**MUJARRAH CANAL BRIDGE
RAMADI, IRAQ**

**SIGIR PA-09-170
JULY 14, 2009**

Mujarrah Canal Bridge

Summary of Report: PA-09-170

Site Photo 7. Concrete deck reinforcing (prior to placing top mat, foreground)

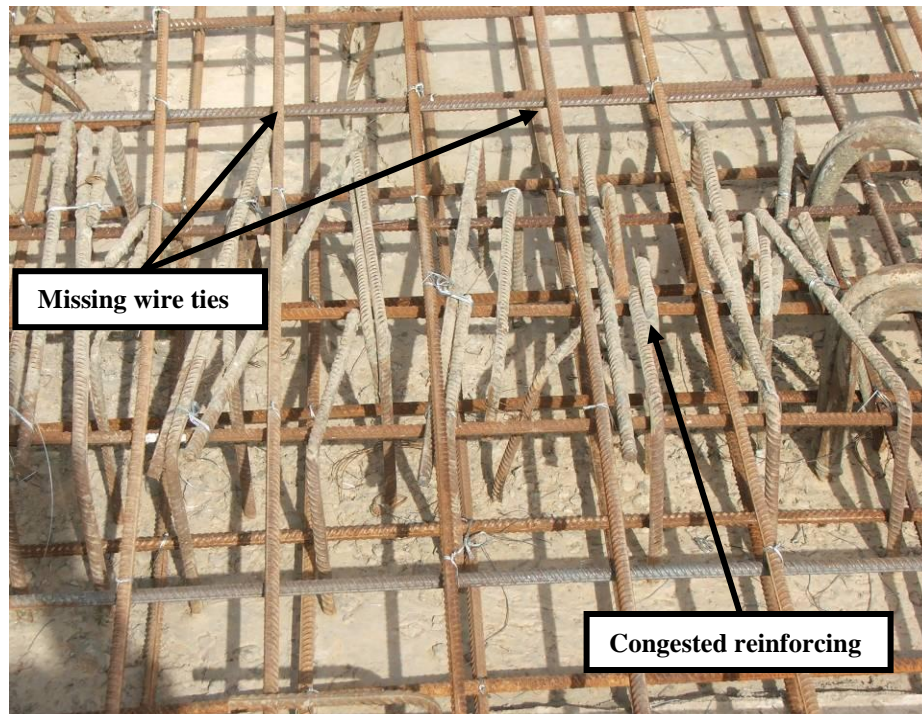
SIGIR noted several issues with the placement of the reinforcing for the concrete deck. For example, near the ends of the girders, SIGIR found areas of severe reinforcing steel congestion (Site Photo 9.) SIGIR is concerned that this configuration of reinforcing steel may prevent homogeneous concrete placement, which would result in voids in the deck. Since the purpose of the reinforcing steel in this area is to create composite action

SIGIR also noted that the bottom mat of reinforcing steel was placed directly on the precast-concrete deck pans. To provide composite action between the reinforcing and the concrete deck, adequate cover needs to be obtained around the reinforcing to permit stress transfer. Inadequate cover may result in the reduced capacity of the deck. SIGIR understands that it is a common practice for contractors to place chairs under reinforcing steel immediately before concrete placement. This helps avoid bending the chairs or rebar when walking on the matting as shown in Site Photo 7. If the contractor placed adequate chairs under the reinforcing steel prior to concrete placement, this is not an issue.

Command Comment. SIGIR's concern with the reinforcing steel matting placed directly on the deck pan is valid. However, it is common practice for contractors to place chairs under reinforcing steel immediately before concrete placement. This helps avoid bending the chairs or rebar when walking on the matting as shown in photograph 7. If the contractor placed adequate chairs under the reinforcing steel prior to concrete placement, this is not an issue.
